GEOSHIELD Verification Report

PROJECT REFERENCE: GEO102848

REPORT NUMBER: 010 REPORT DATE: 22/09/2022

PROJECT: Galiford Try Building

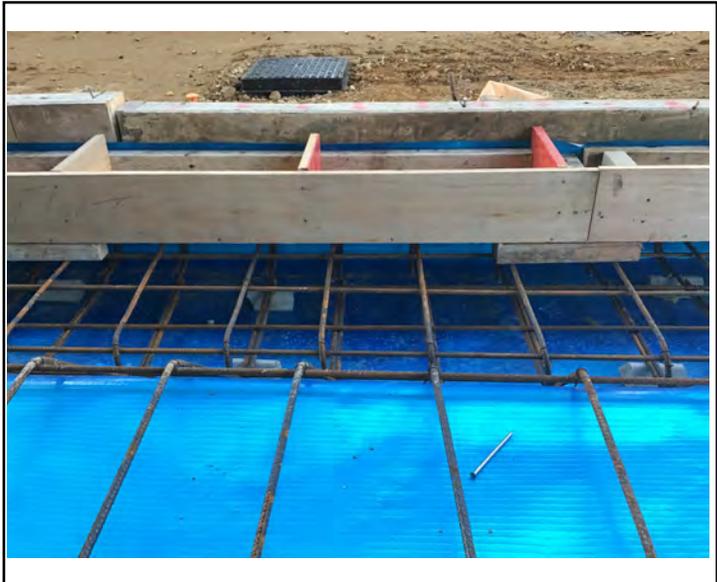
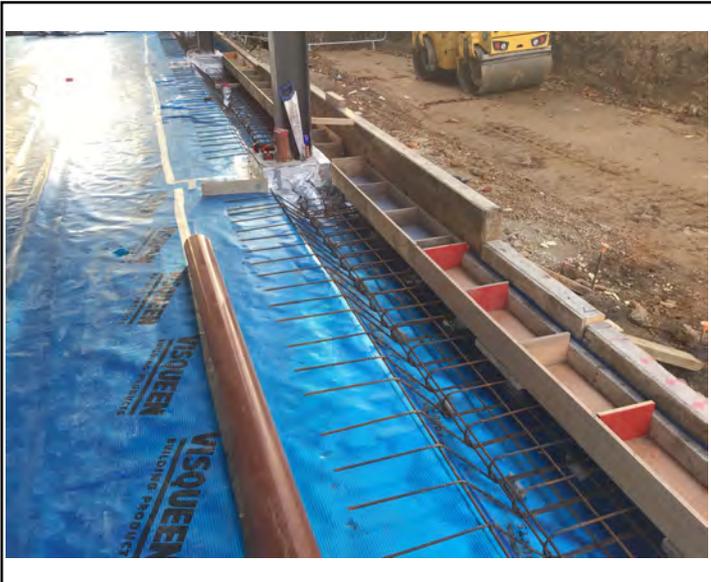
RESTRICTIONS AND LIMITATIONS: Steel work had started to be installed

This restricts our ability to verify the Visqueen GB under the installed steel

Images above show installed steel work and ply shuttering

These areas can still be visually inspected for punctures, however the seams

Cannot be exposed as easily

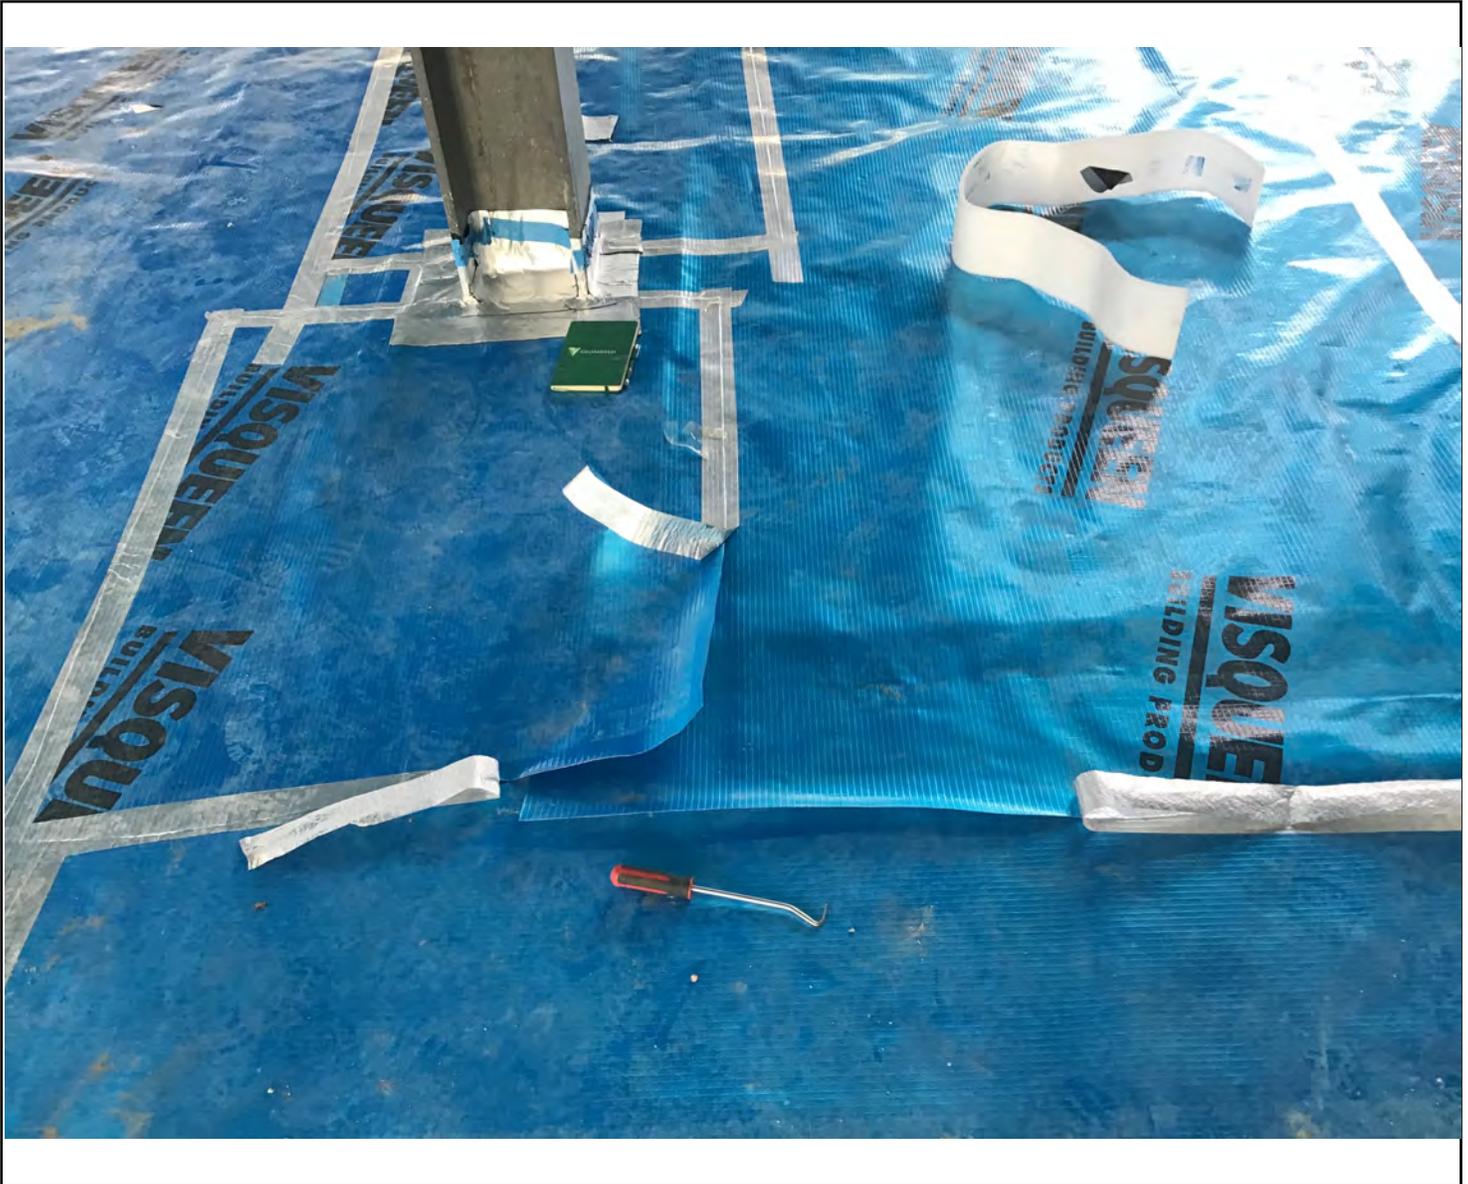
Another image of exposed seams to conduct an MPST

In total 9 seams were exposed for inspection with 6 of them requiring remediation

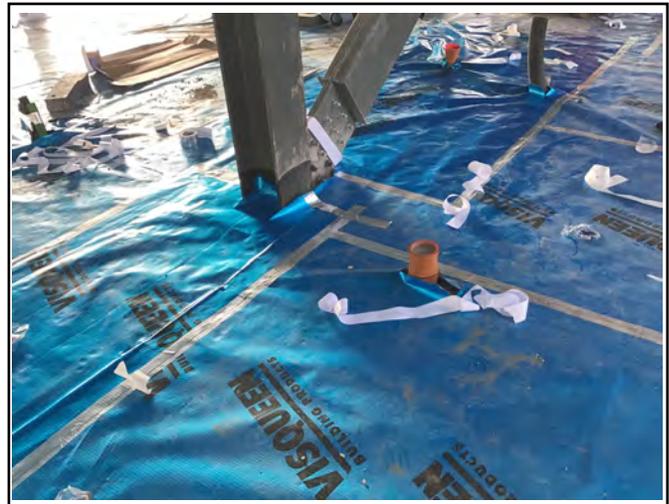
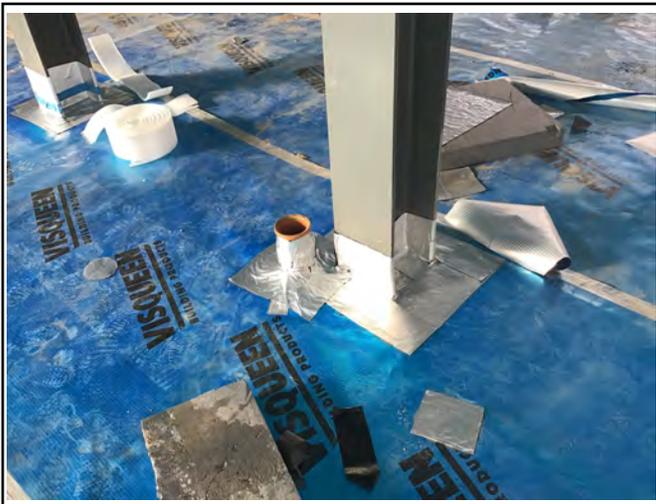
Multiple pipe and stanchions required sealing with Visqueen Gas Resistand Self

Not all of these had been completed when we visited

The image on the left shows a completed example that was subject to an MPST

The image on the right shows an incomplete penetration detail

Incomplete penetration details limited the ability to verify the

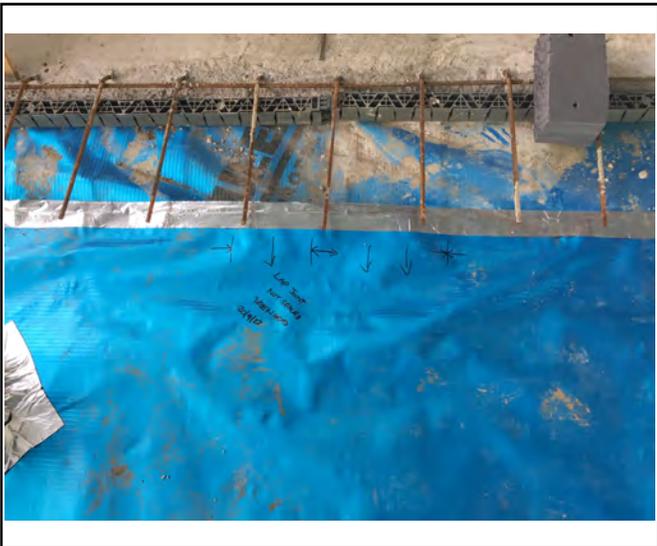
Butyl tape unbonded

Butyl tape unbonded

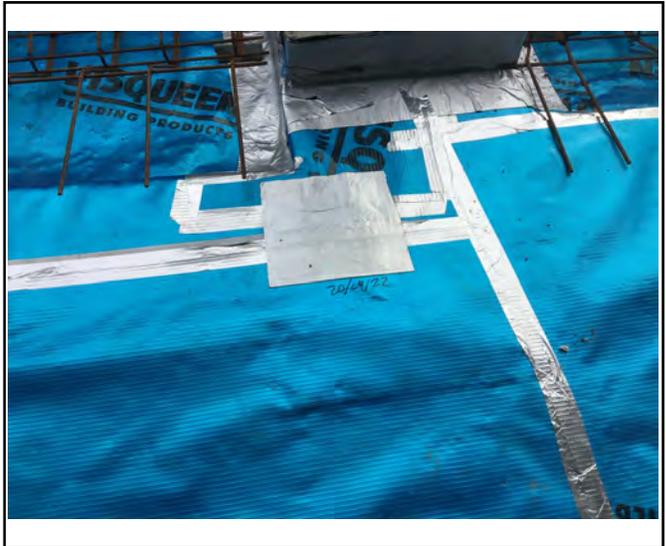
Remediation required

Missing membrane

GRSAM patch

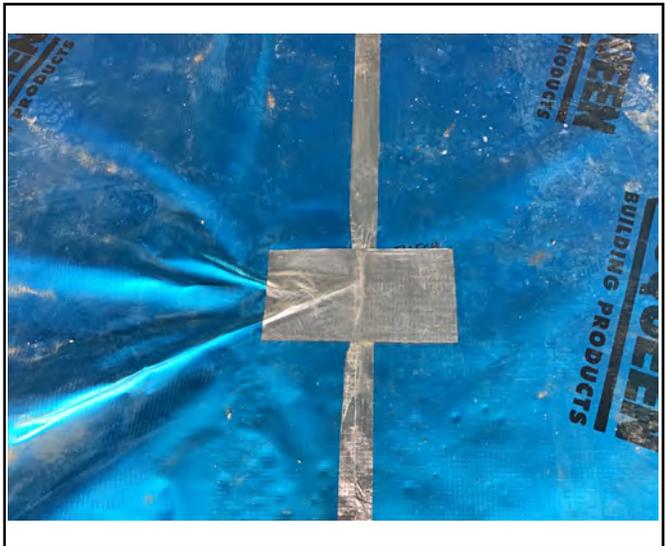
Remediation required

GRSAM patch

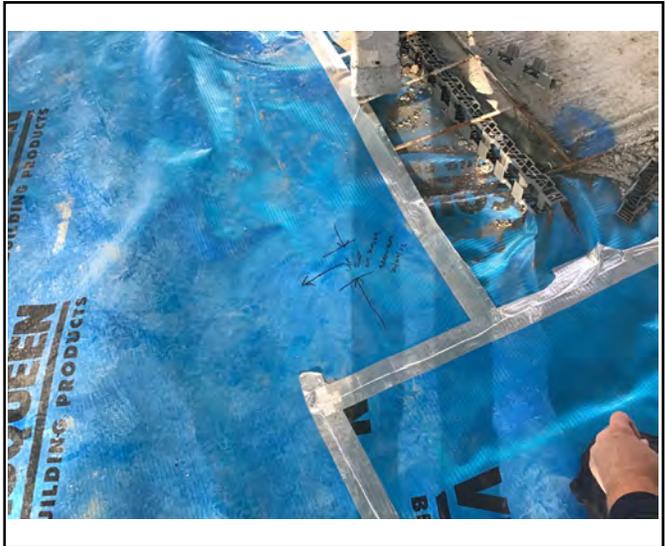
Seam missing butyl tape

Seam with previously poured concrete

Pipe penetrations unsealed under

Steel reinforcing bar

Perimeter detail missing

Butyl tape

Completed during visit

Remediation plan drawn up

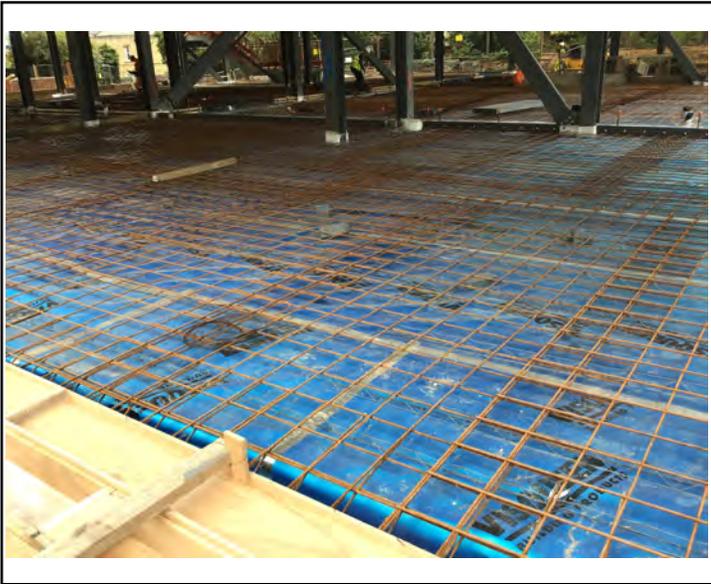
RESTRICTIONS AND LIMITATIONS: Steel reinforcing bar has been laid

The image on the right shows a pipe penetration shuttered and filled,

This limits the ability to check all the GRSAM has adhered correctly

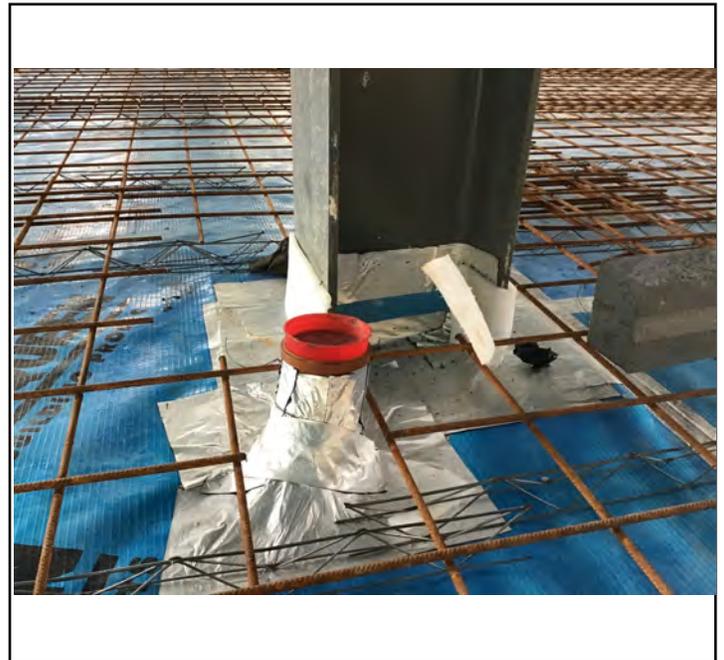
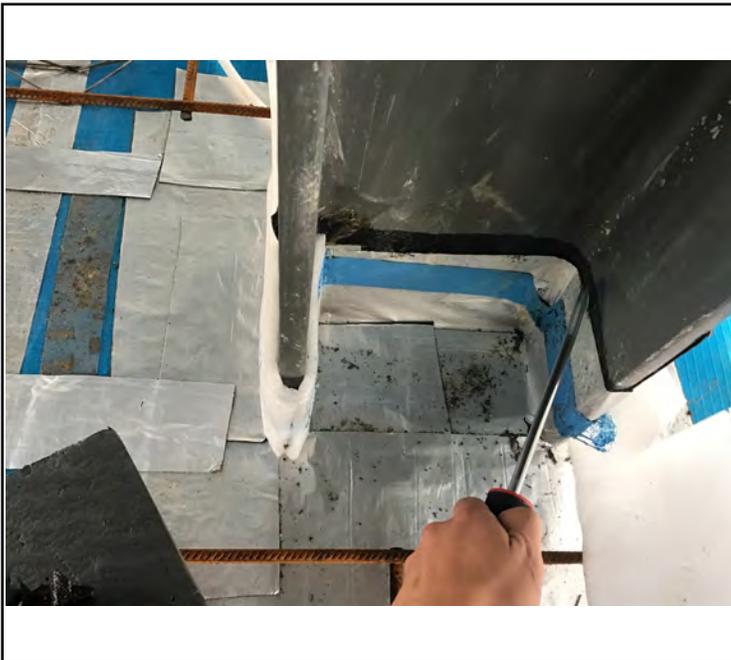
In the previous visit the stanchions had not been sealed, this required remediation prior

The images above show the stanchion seal being subject to a mechanical point stress

To the concrete being poured. The stanchions have been sealed using visqueen Gas

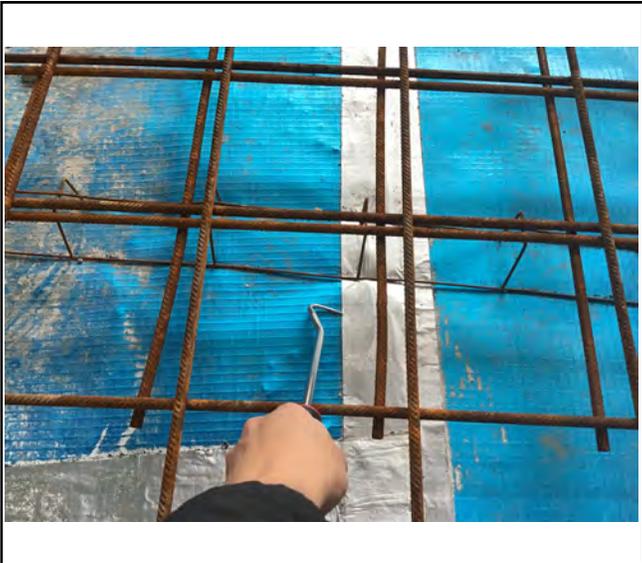
NOTES: In the previous report it was noted that there was an

Insufficient bond formed round the two previously poured concrete areas

The above left image shows the length of one side of the concrete slab that

Required remediation with GRSAM present (red line)

It was agreed that GRSAM would be used in these areas to complete the bond

The above right image show a MPST being carried out on the GRSAM

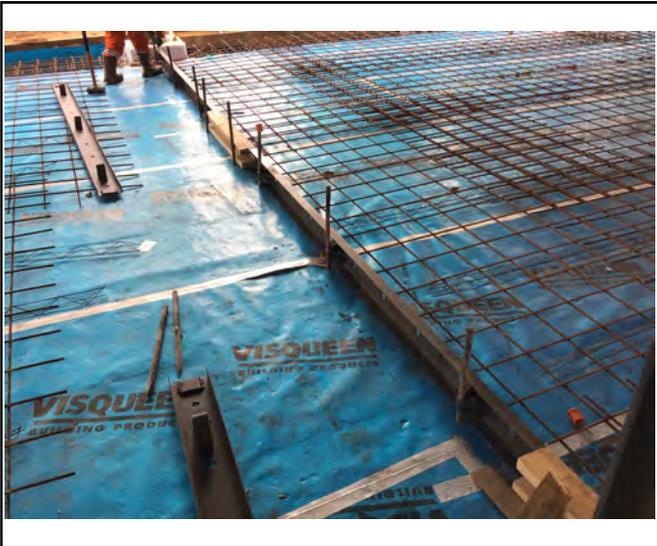
Shuttering pins will require

GRSAM patches

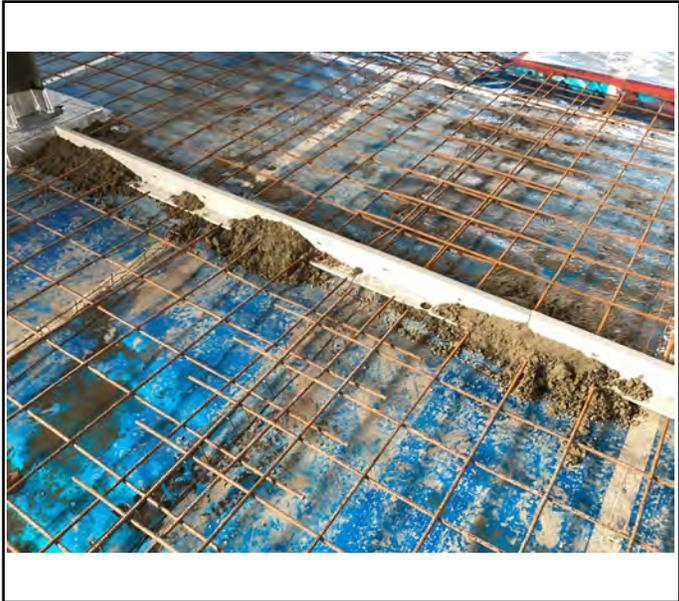
The images show one of two screed rails which been secured on top of the Visqueen

Gas Barrier with a weak concrete mix. This limited the verification of the Visqueen Gas

The image shows the extent of one of the two screed rails.

The image on the right shows a close up of both the screed rail and the

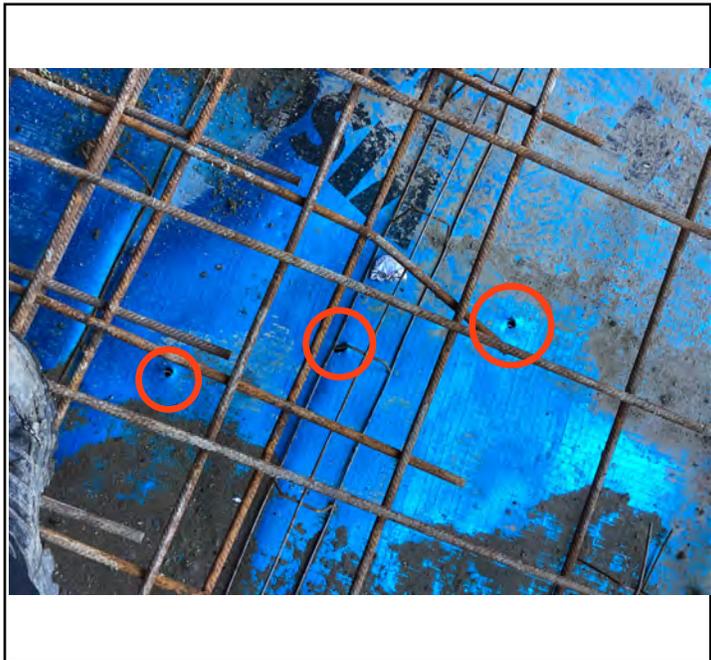
The Visqueen Gas Barrier has been installed upon a layer of insulation (substrate) which provides an ideal bearing from any potential damage from underneath. The area was however visually. The images show (red circles) punctures which are likely to have been

during the verification visit and recorded in 'additional photos section' this report.

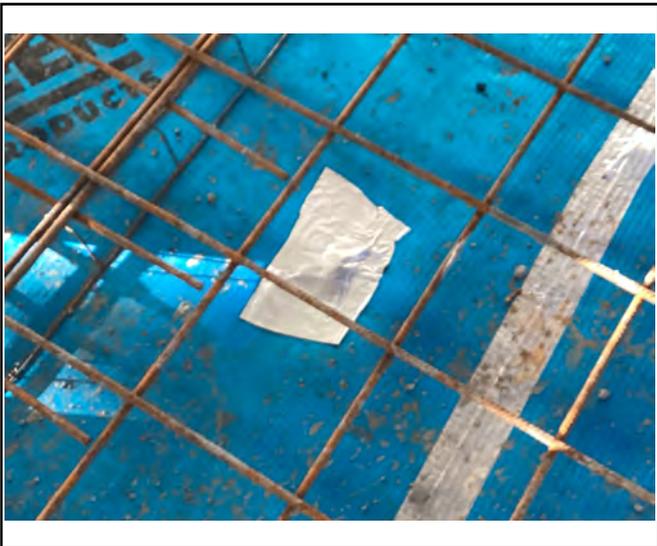
Puncture to Visqueen Gas Barrier

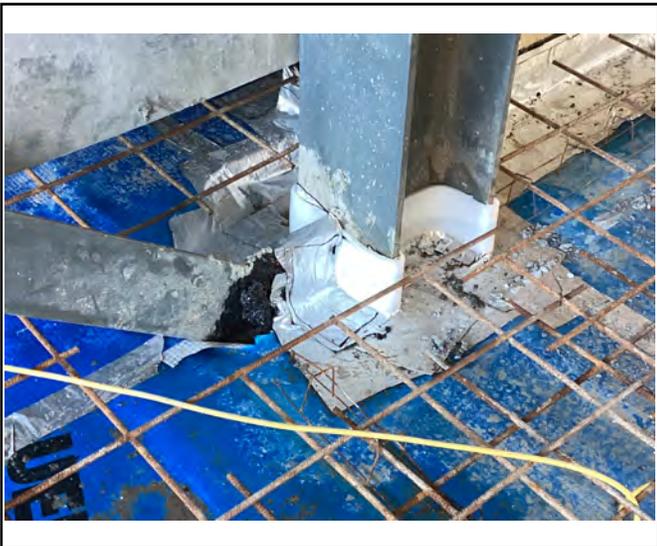
Puncture to Visqueen Gas Barrier

identified as Verification Item Two

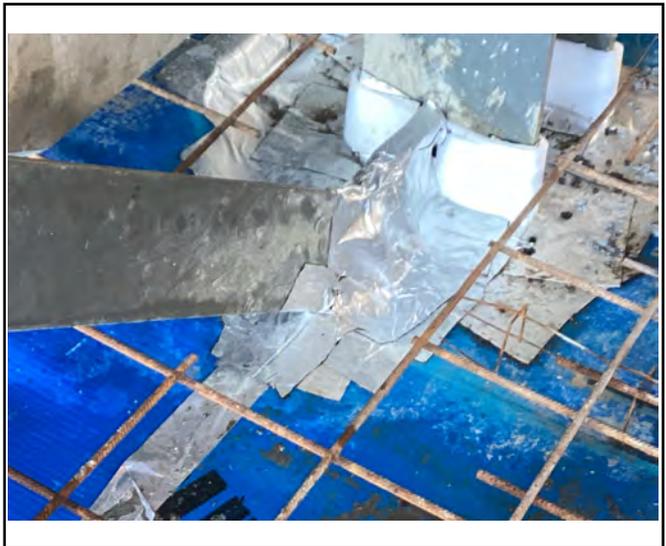
View of incomplete steel bracing

requiring remediation

Remediation to steel cross bracing
